Agenda
City of Springboro Planning Commission Meeting
Wednesday, April 13, 2022, 6:00 p.m.
Council Chambers, City Building, 320 West Central Avenue

Background Information & Staff Recommendation
City of Springboro Planning Commission Meeting
Wednesday, April 13, 2022, 6:00 p.m.
Council Chambers, City Building, 320 West Central Avenue

Revision to Final Development Plan, 765 West Central Avenue (SR 73), PUD, Planned Unit Development, LaComedia Dinner Theater, construction of accessory structure

Minor Revision to Approved General Plan, The Springs PUD, Planned Unit Development, revision to apartment component

Record Plan

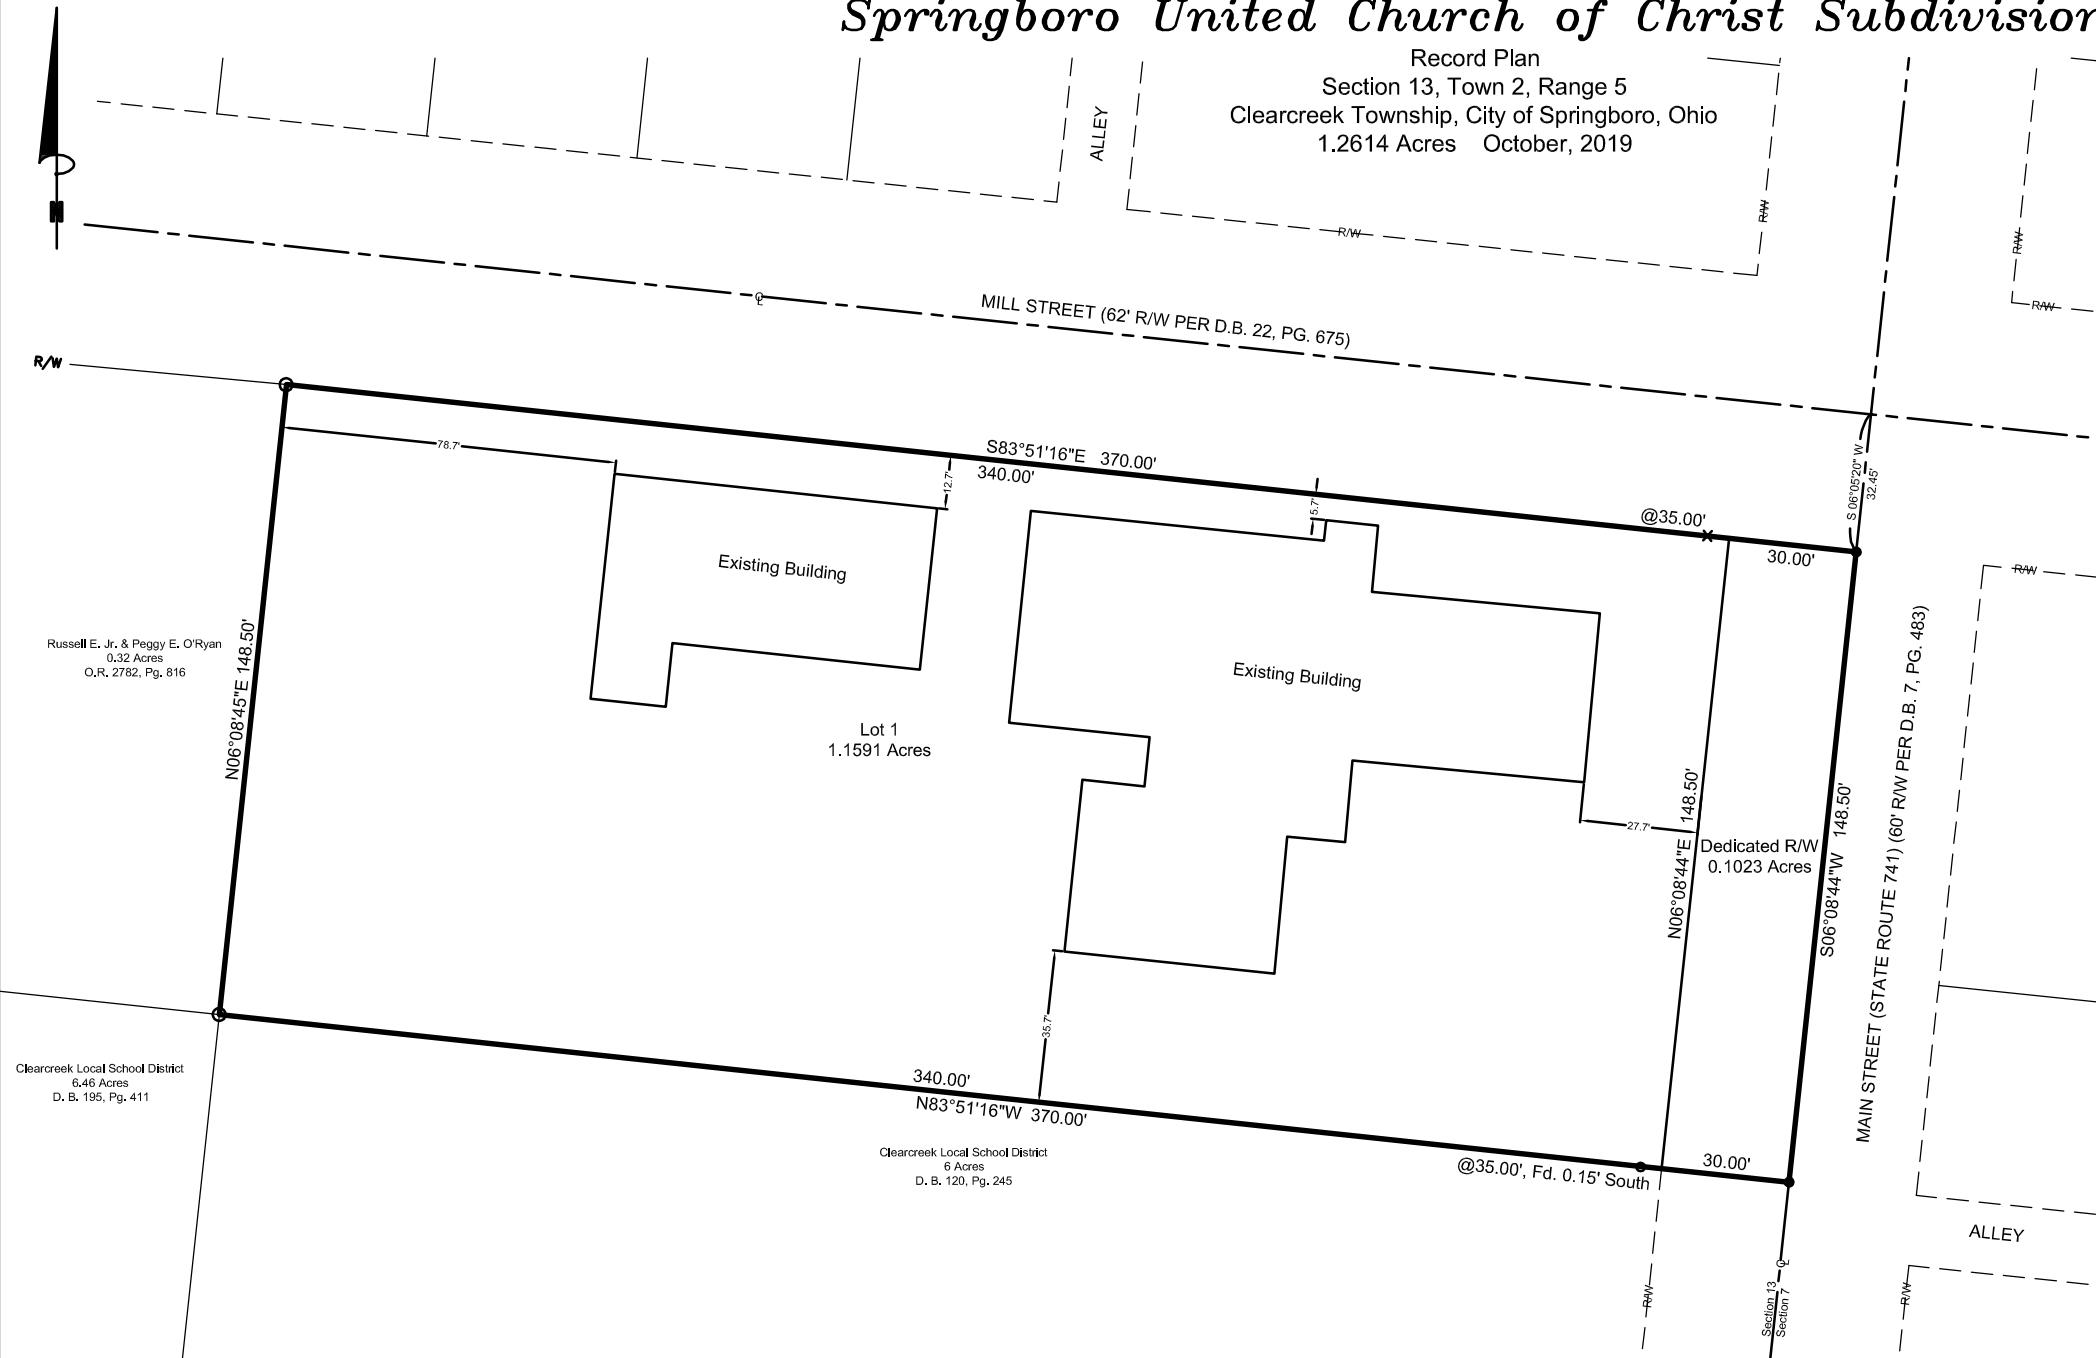
1. Revise the Title Block with the word "Record Plan" on the first line, and then "Springboro United Church of Christ" below it on the second line.
2. Submit to Warren County for their review and comments. Revise accordingly

SHEET C3
OF 4

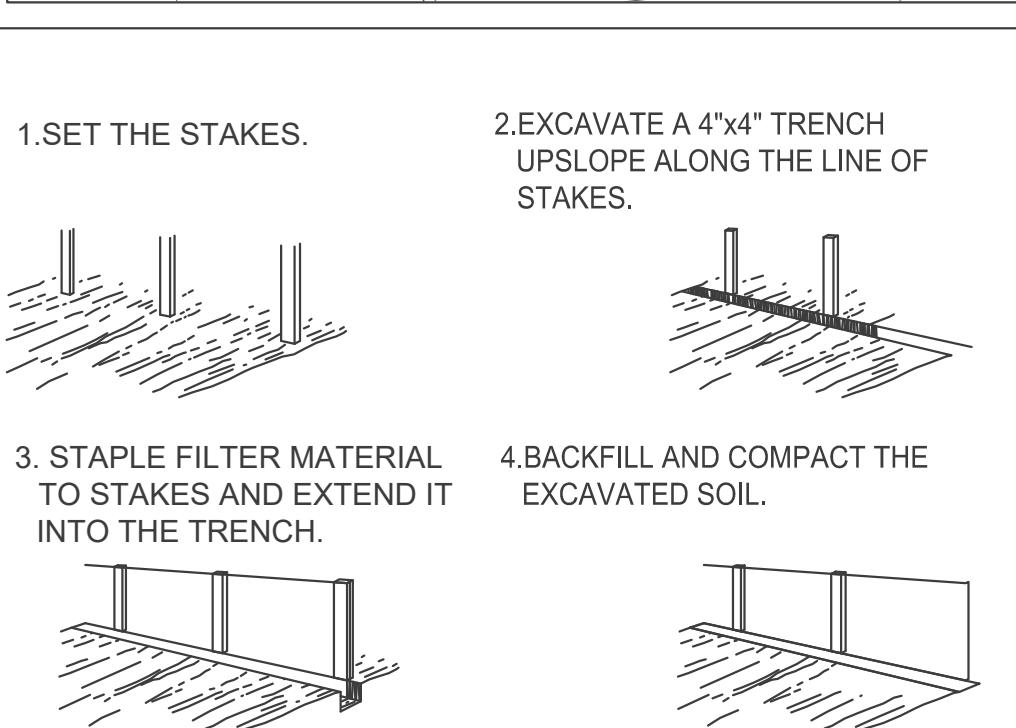
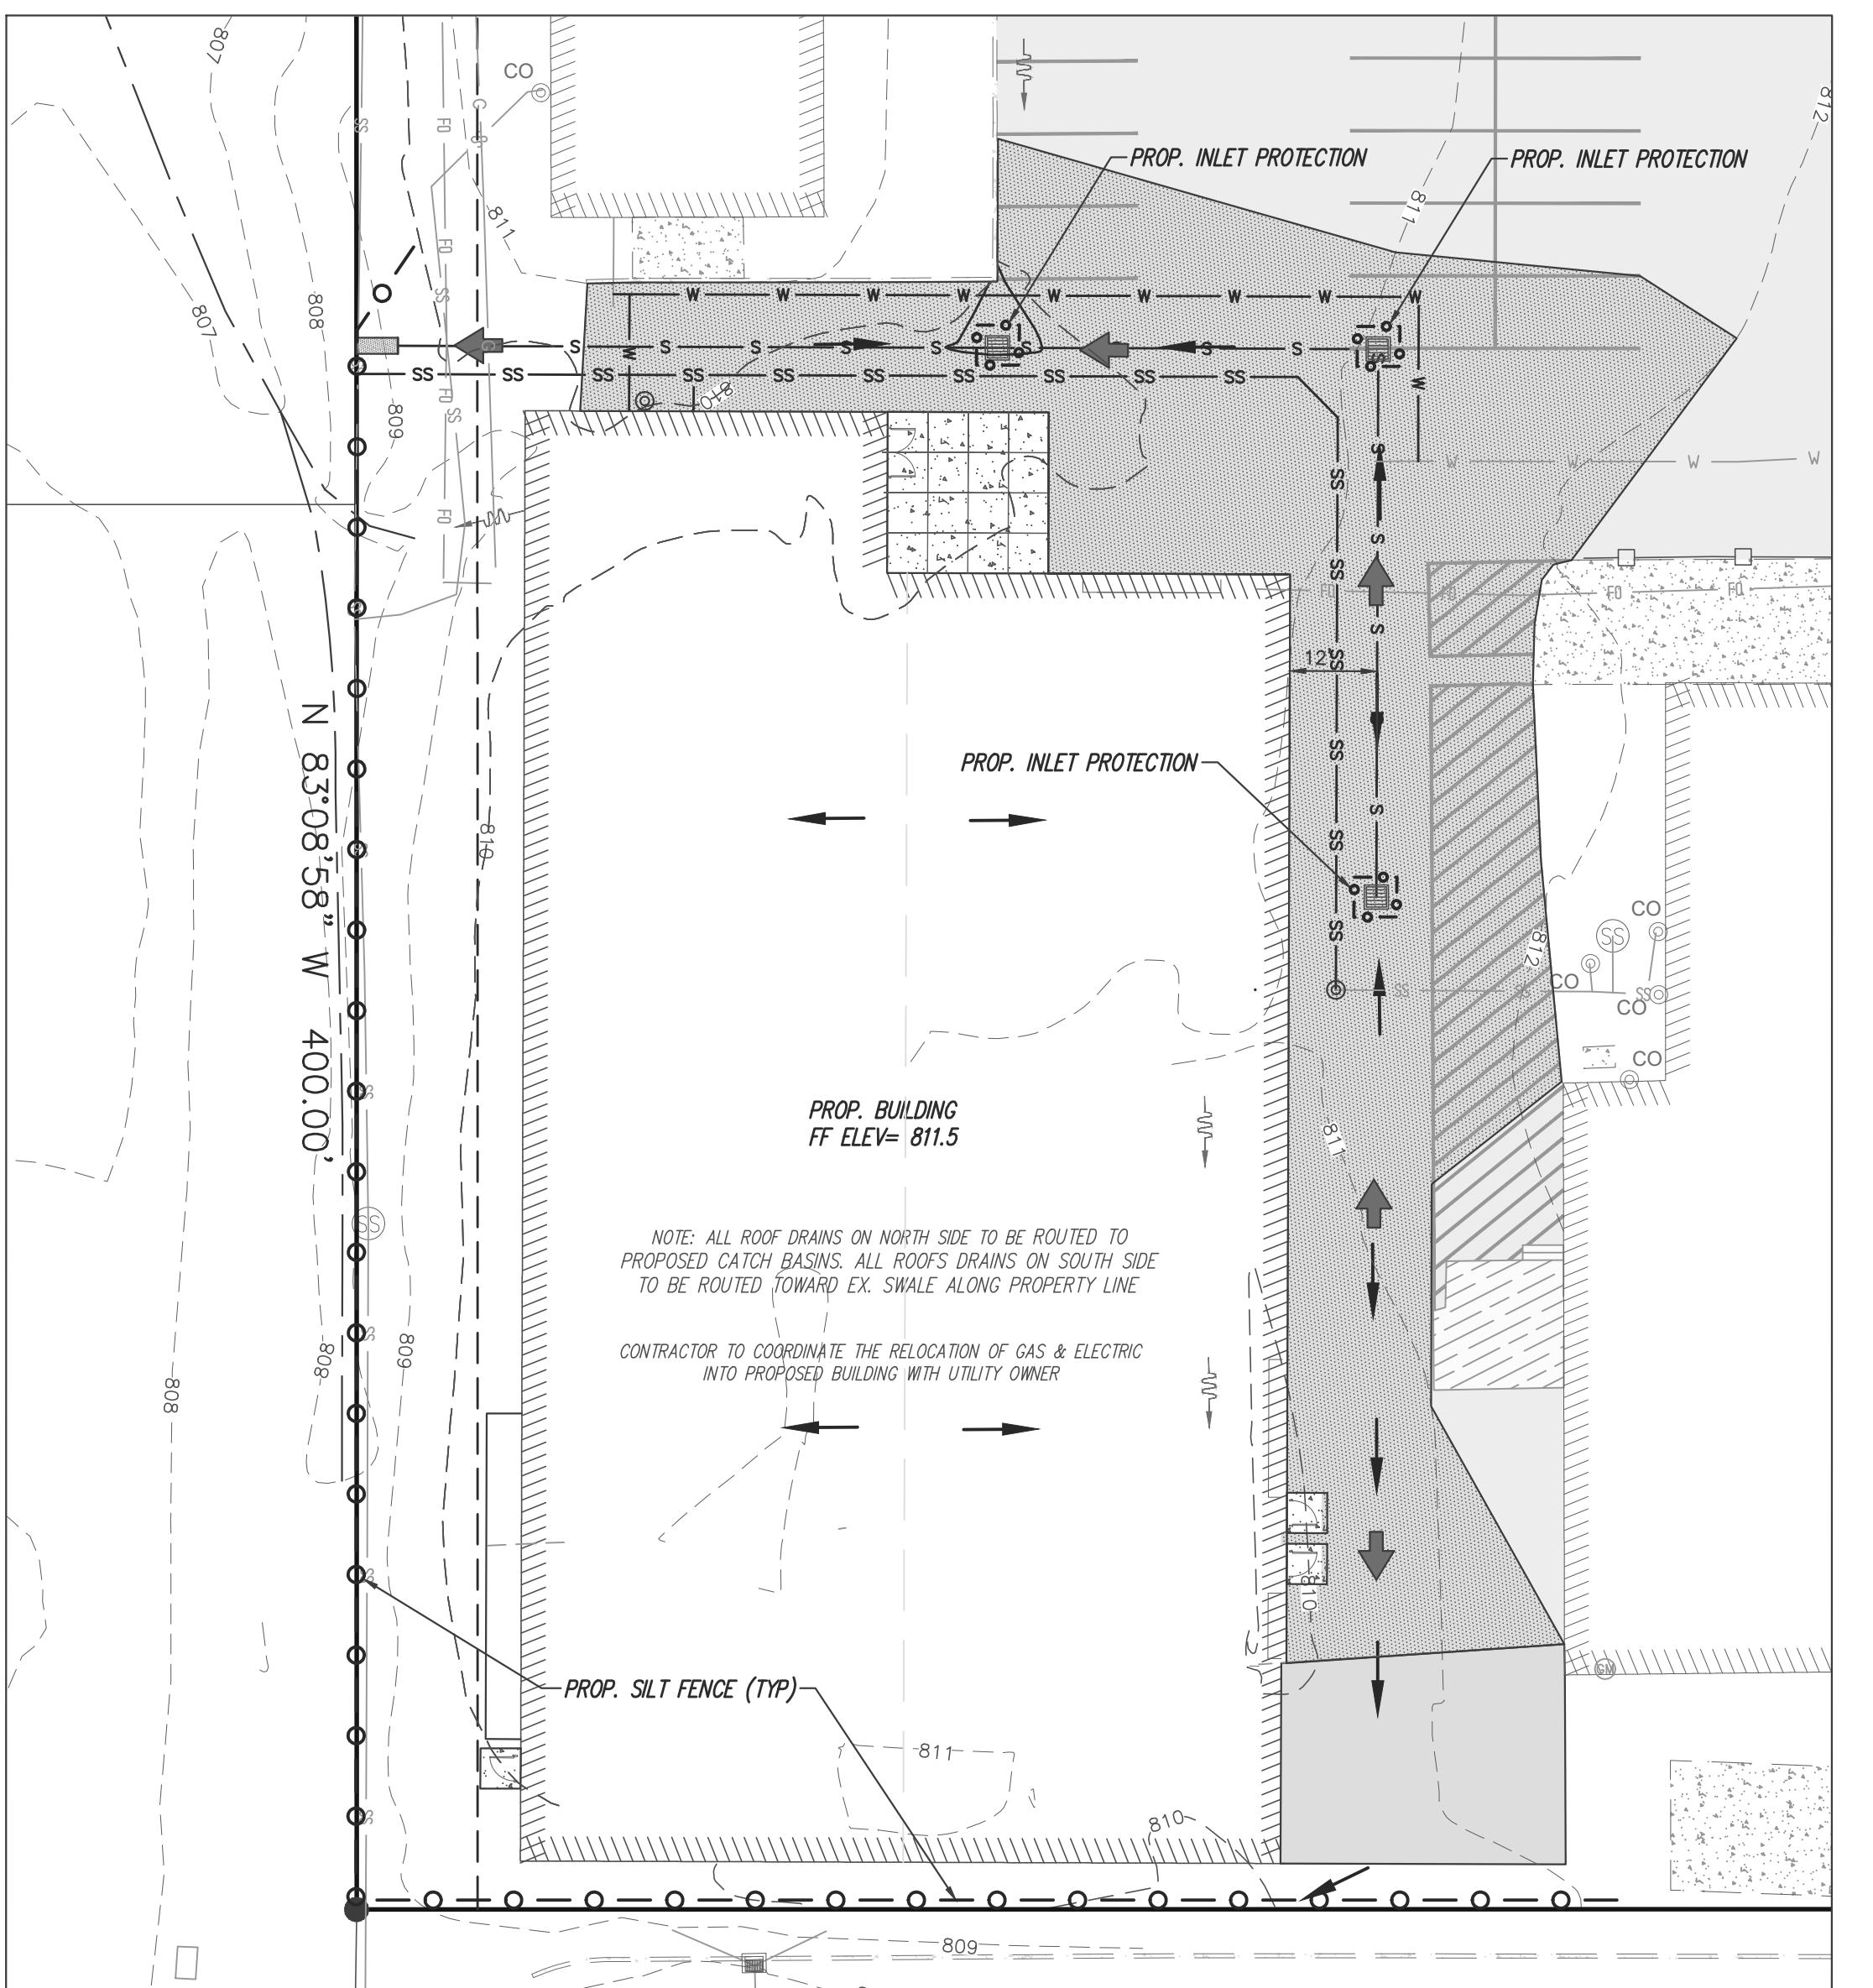
2. Provide water and sewer lateral information. Water to be minimum 1" K copper with remote reader inside of building and sanitary sewer lateral to be min 6" SDR 35 or SCH 40 material at 2% slope minimum.

3. Provide the pervious/impervious change on the site due to the new building and associated construction. Storm water on the additional impervious areas to be detained.

4. Name sheet C4 "Stormwater Pollution Prevention Plan".
5. Verify that the proposed storm sewer outlet will not create ponding due to elevations. Provide proposed contours at this location and throughout the site.

TITLE SHEET

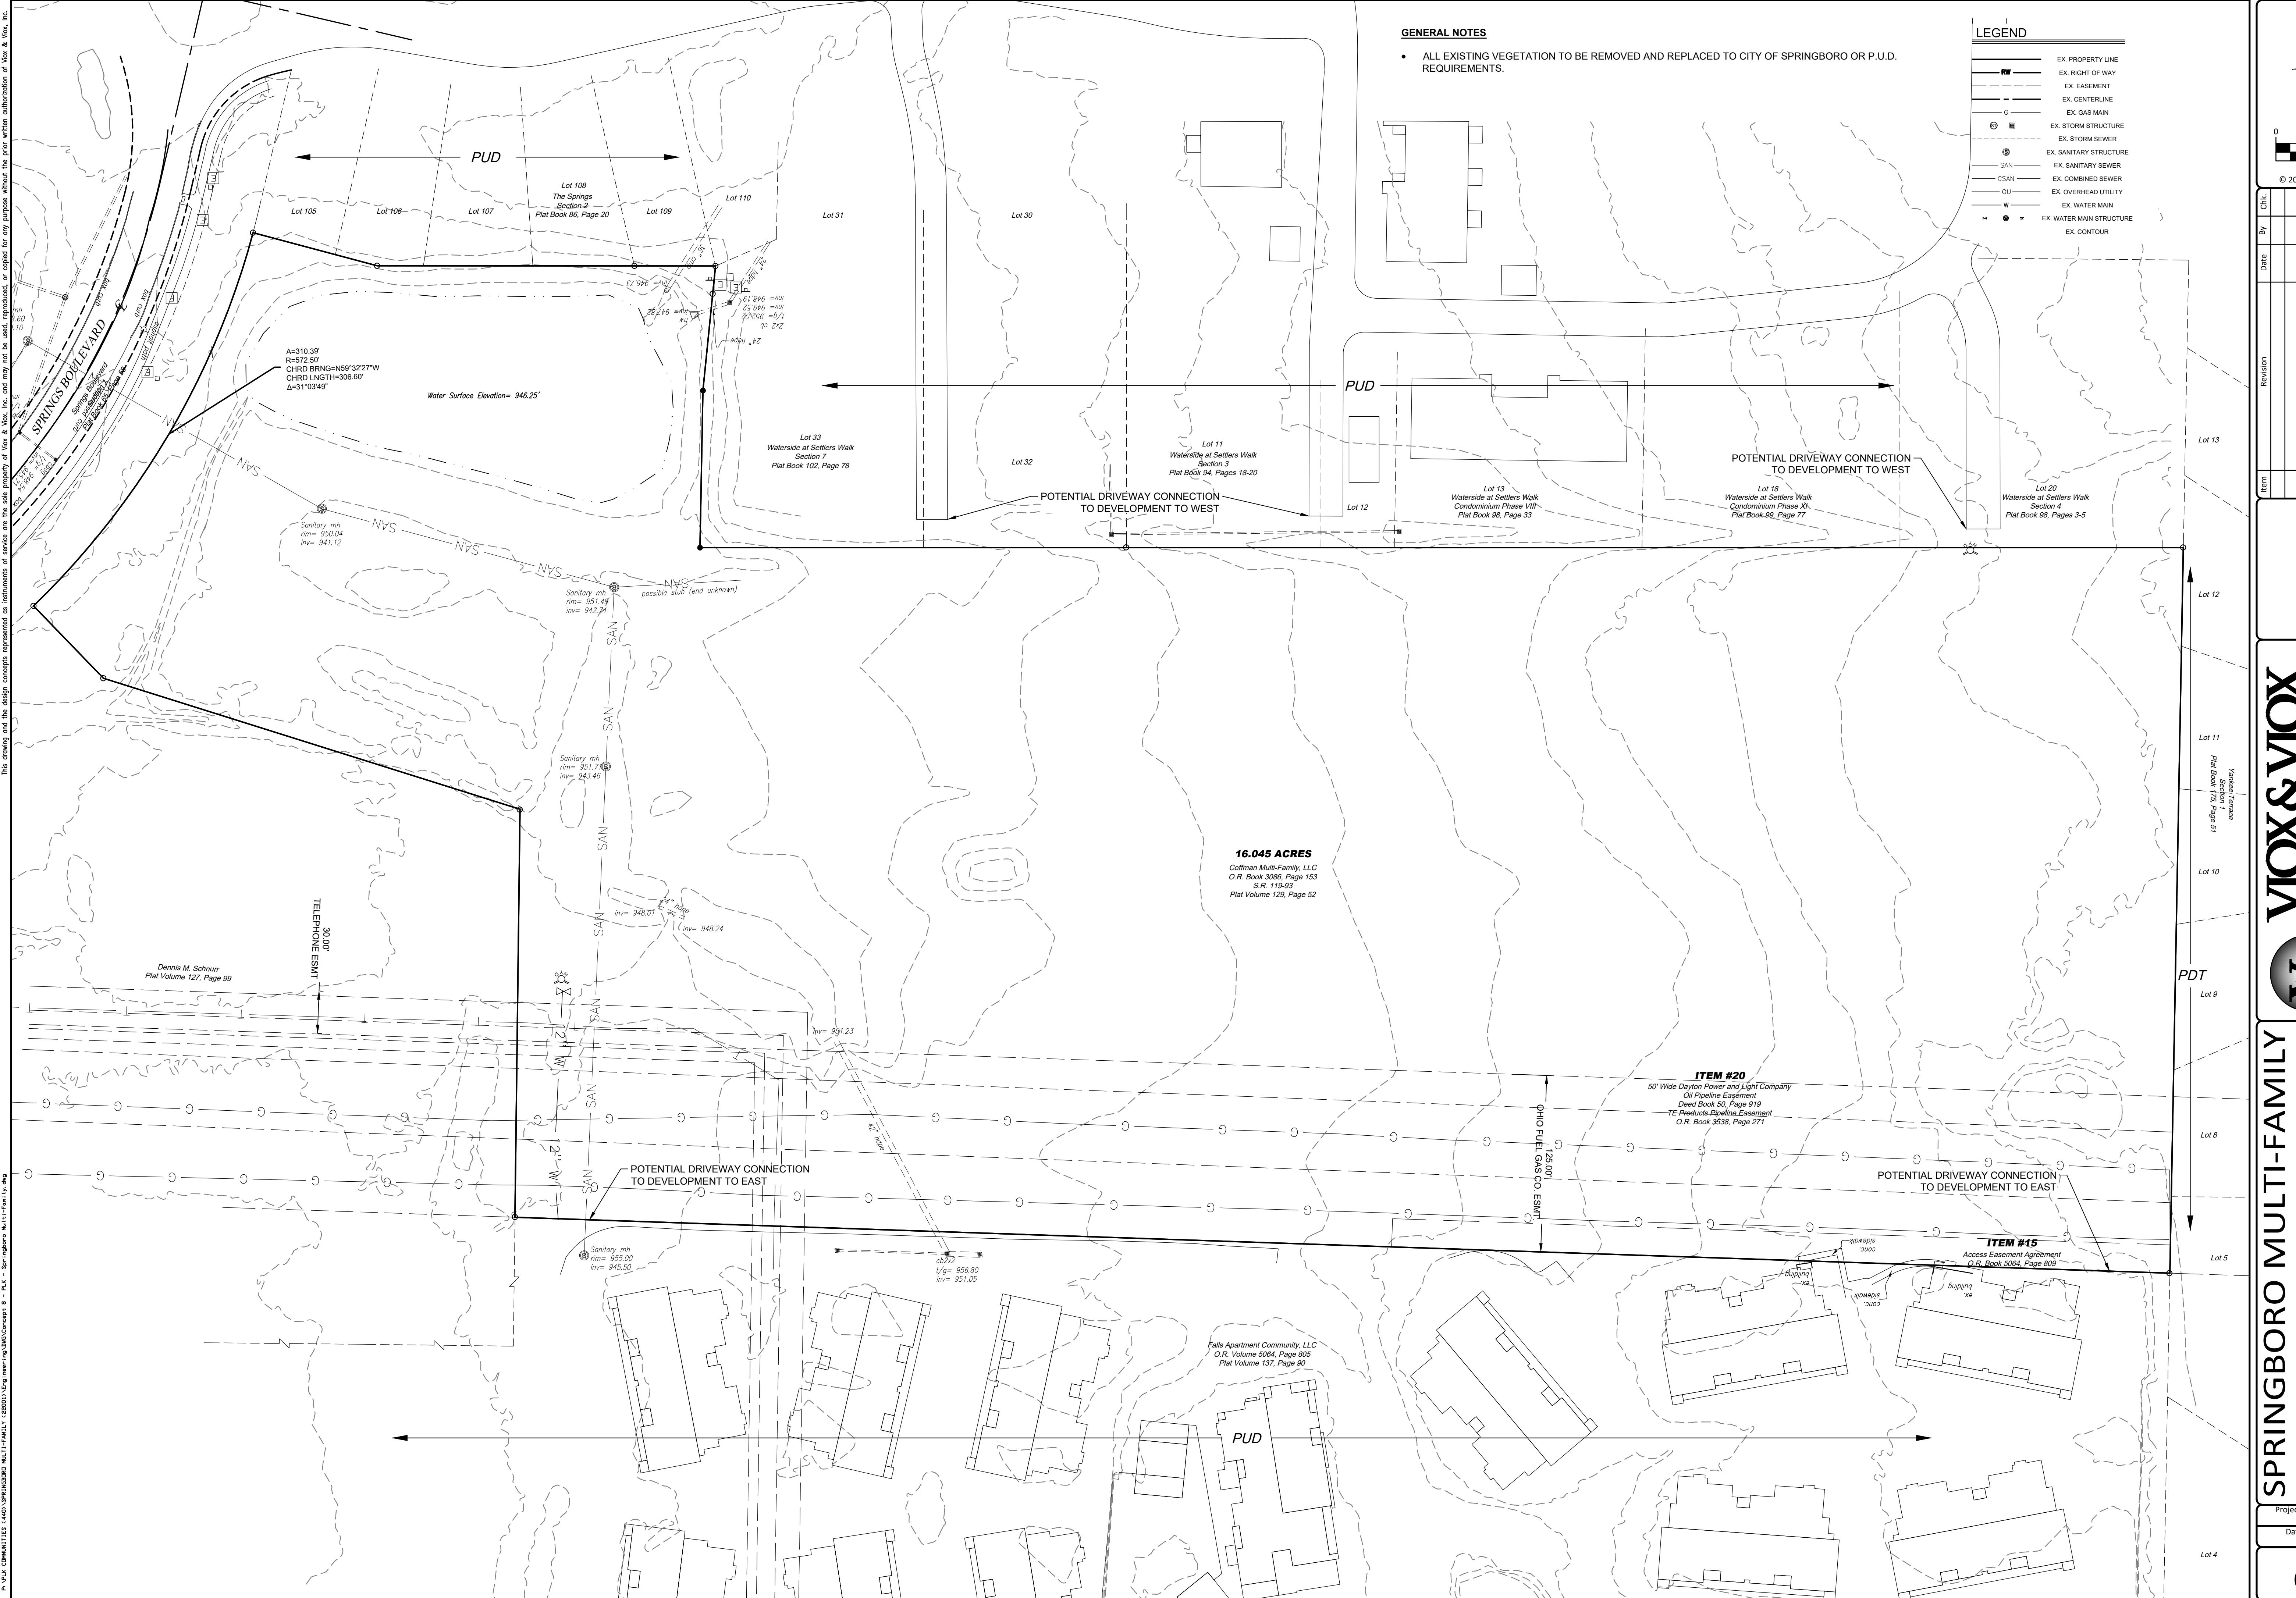
1. Revise plans to indicate this stage of the approval process as general plan approval. The second stage of the approval process is final development plan, not site plan review.
2. Provide architectural details for a typical residential building on the site including materials, color, and scale, to be included in the general plan revision record.
